## PROFESSIONAL RECOMMENDATION MEMORANDUM

**Project Name: Engineering Support Services and Recommendations for Roadside Safety Issues/Problems for Member States**

**Task 21-09: Oregon 32-inch F shape Pin and Loop vs Portable Concrete Barrier (PCB) Tested**

**DATE: September 9, 2021**

Figure 1. Comparison of Horizontal Holes

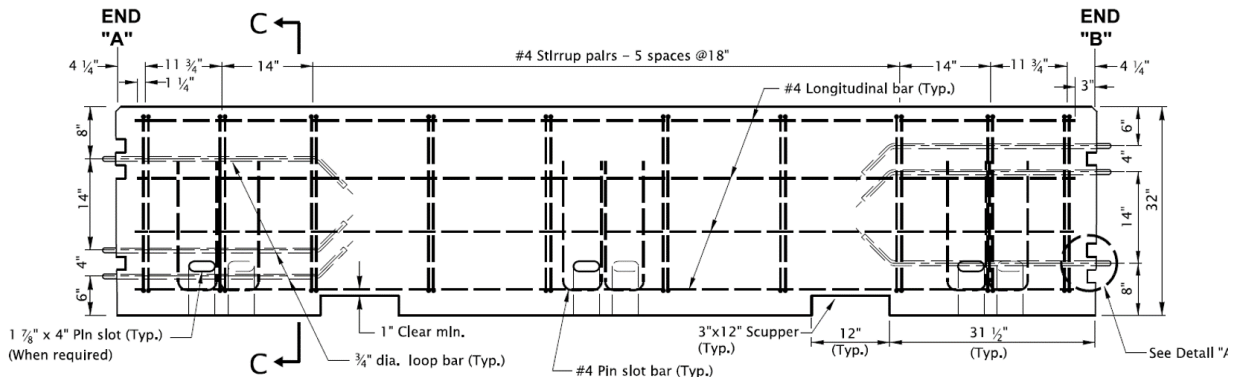
There are two horizontal holes located at 32-inch away from each side end and 15-inch away from the top face in the pooled fund barrier. These holes are embedded for shipping and construction lifting purposes, and there is no structural perspective involved. Thus, TTI researchers believe these holes are not necessary although it is recommended for easier shipping and placement.

**Figure 2. Location of the slots on barriers**

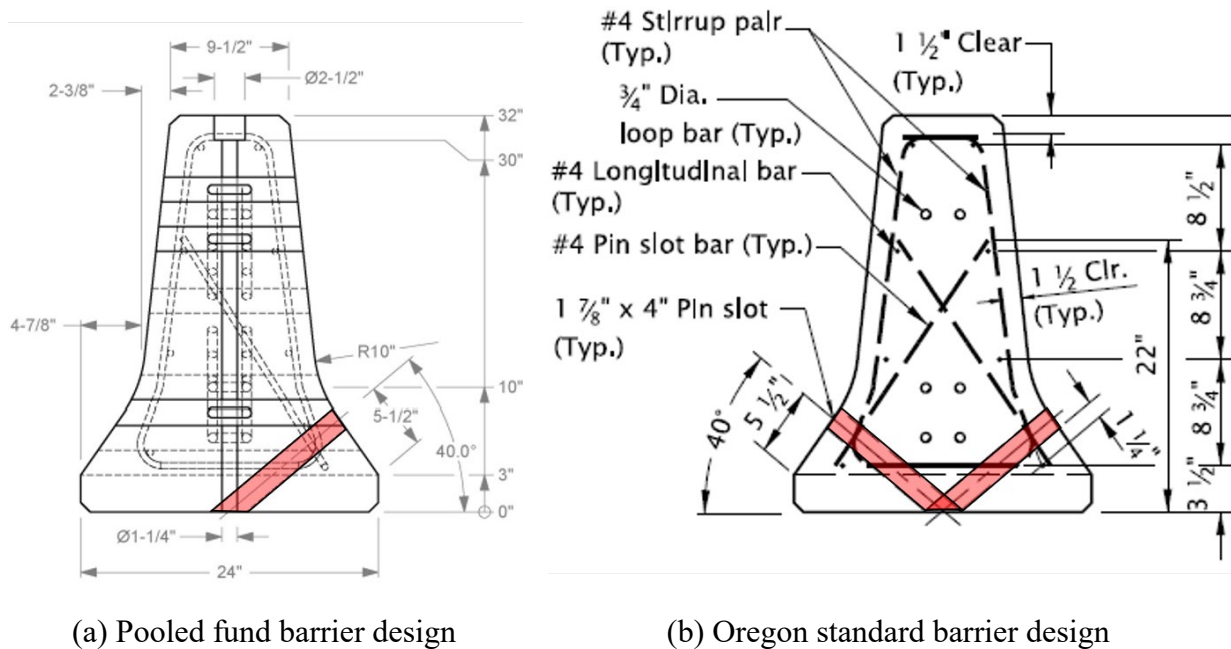
As shown in Figure 2, the pooled fund barrier design has one side slot in the barrier that can be pinned on the traffic side for temporary traffic control. The Oregon standard barrier design has two side slots in the barrier which can be pinned on both traffic and field sides to be suited for median barrier installations. Given that slots are located in the bottom part of the barrier which is expected to be under tension at the vehicle's impact moment, a reduced concrete area due to additional slots may not deteriorate the overall barrier's performance as long as the appropriate reinforcement is placed. Thus, the overall performance of the F-shaped barrier may not be affected by additional slots on the other side (field side).

**Figure 3. Washer and Connecting pin**

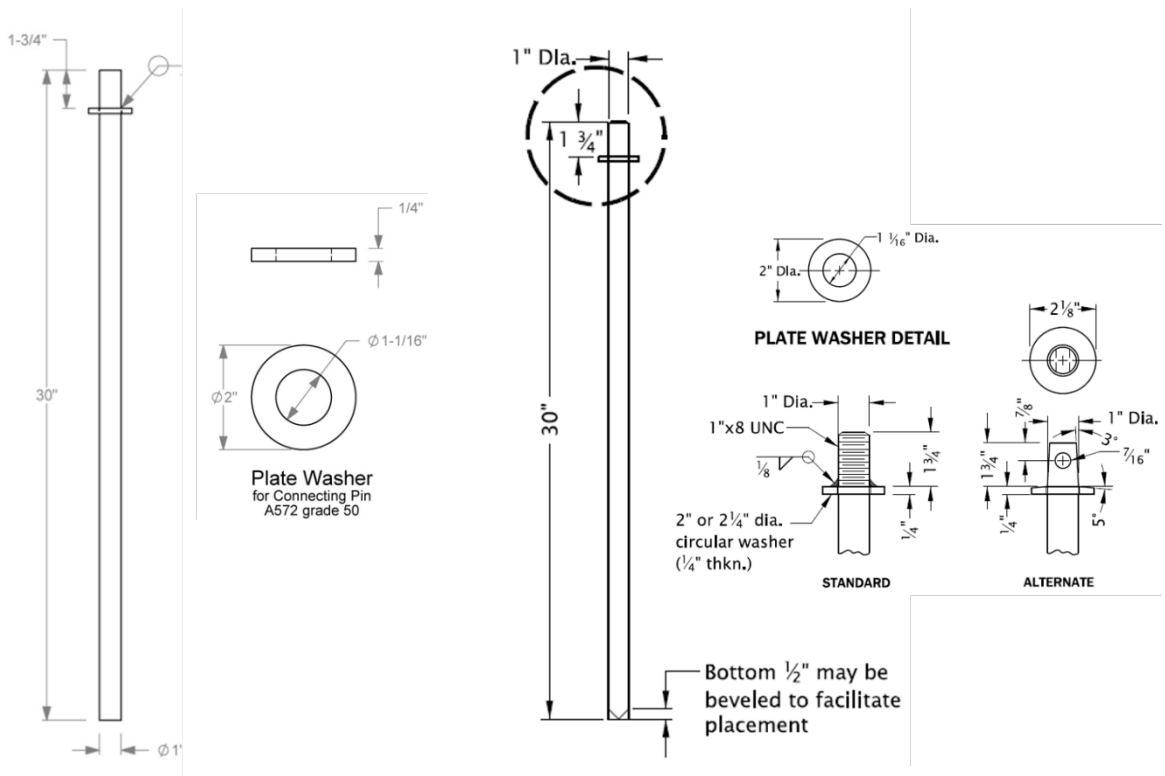
Figure 3 shows details of the connecting pin and washer from both designs. In a pin-and-loop type connection, the connection of adjacent precast barrier segments is established by a connecting pin (made of ASTM A 449 steel in the pooled fund barrier). The structural connection capacity is thus mainly based on the connecting pin and the loops. Considering that washer is a nonstructural part used to help the connecting pin hold its position, a slight difference in diameter (0.25 in. for standard washer and 0.125 in. for alternative washer) can be negligible. Also, whether the face of the top and bottom pin is 'squared off' or 'beveled' is not expected to make any difference as those are not in the shear critical location. TTI researchers recommend welding washers to the connecting pin.

**Figure 4. Comparison of Stirrup Detailing**

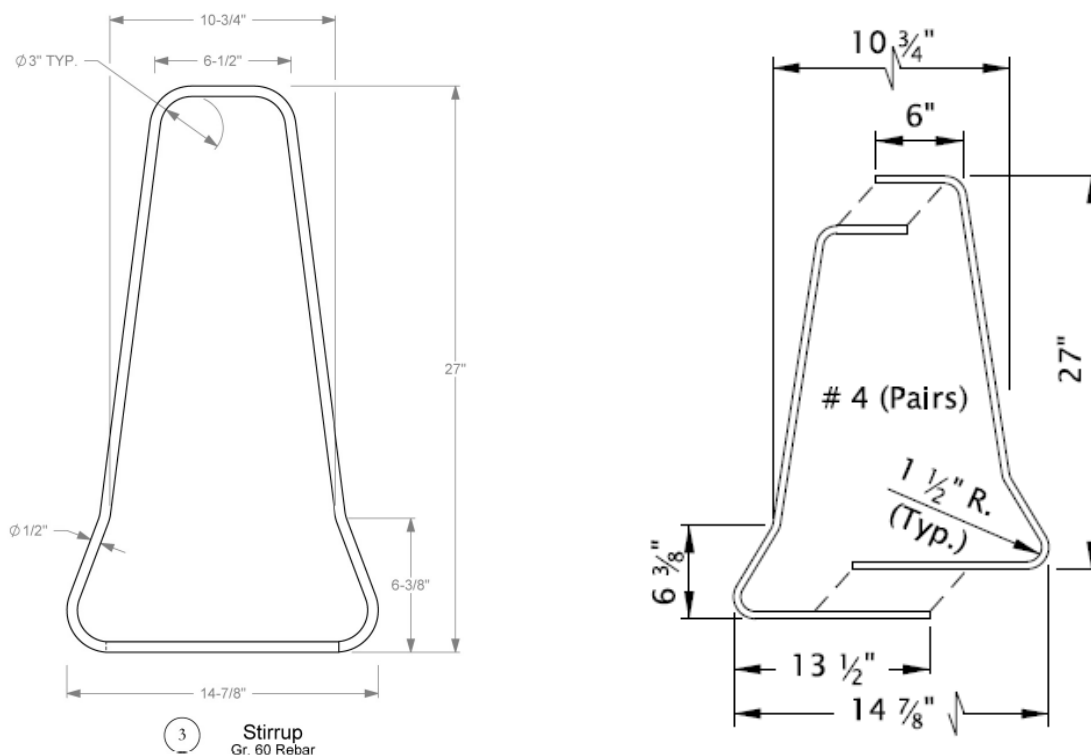
Figure 4 shows stirrup placed on both designs. As shown in the figure, closed stirrup fabricated as a single piece is used in the pooled fund barrier design while spliced stirrup is used in the Oregon standard drawing for better constructability. TTI researchers believe the splice stirrup is acceptable as long as properly anchored and spliced with an adequate length of laps in accordance with AASHTO Article 5.10.8. Also, the top and bottom splice used in the Oregon standard drawing is a preferable splice detailing as the splice is located away from the direction of action of shear forces (Birely et al. 2018).
